Access Compliance Report

Public Rights-of-Way

(Curb Ramps)

Intersection ID: N/A	Main Street: FAIRVIEW_RD	Cross Street: PROVIDENCE_RD	Location: SW
ADA ID: 8202E1D37AF7	Ramp Type: Perp	Initial Pass/Fail: Fail	Overall Compliance: No
Codes/Mitigation Info/Possible Solution		Field Measurements/Component Compliance	
Severity Score: 48.75

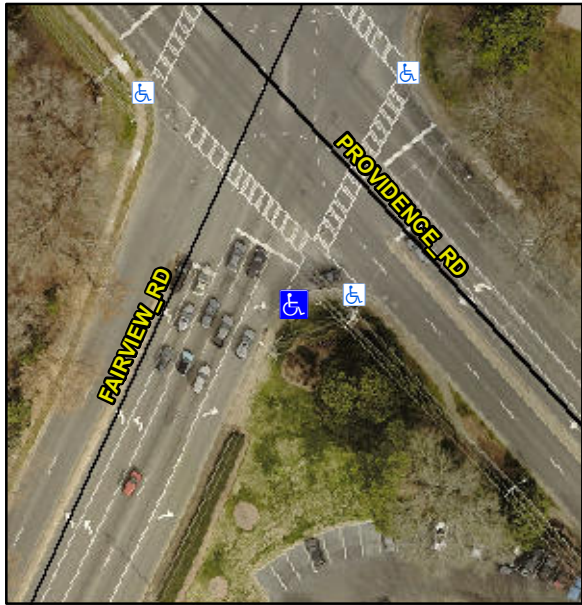
Not Found, R304.5.1, R304.2.2, R304.5.3

Compliance	Description	Data	Compliance	Description	Data
N/A	Ramp Length (in)	59.0	No	Ramp Slope (%)	9.0
No	Ramp Width (in)	31.0	No	Ramp XSlope (%)	2.1
N/A	Flare Type LT	N/A	N/A	Flare Type RT	N/A
N/A	Flare Slope LT (%)	N/A	N/A	Flare Slope RT (%)	N/A
N/A	Flare Traversable LT?	N/A	N/A	Flare Traversable RT?	N/A
N/A	Landing Length (in)	N/A	N/A	DWS Provided?	N/A
N/A	Landing Width (in)	N/A	N/A	DWS Contrast?	N/A
N/A	Landing Slope (%)	N/A	N/A	DWS Length (in)	N/A
N/A	Landing X Slope (%)	N/A	N/A	DWS Full Width?	N/A
N/A	Landing Curb? (Y/N)	N/A	N/A	DWS Offset (in)	N/A
N/A	Shared Landing?	N/A			
N/A	Gutter Ponding?	N/A	N/A	Gutter Slope (%)	N/A
N/A	Gutter Lip Ht (in)	N/A	N/A	Gutter X Slope (%)	N/A
N/A	Painted X Walk1?	Yes	N/A	Painted X Walk2?	N/A
	X Walk 1 Direction	To NW		X Walk 2 Direction	N/A
N/A	X Walk 1 Width (in)	110.0	N/A	X Walk 2 Width (in)	N/A
	X Walk 1 Slope (%)	3.5		X Walk 2 Slope (%)	N/A
	X Walk 1 X Slope (%)	1.2		X Walk 2 X Slope (%)	N/A

Remove & Replace Entire Ramp.
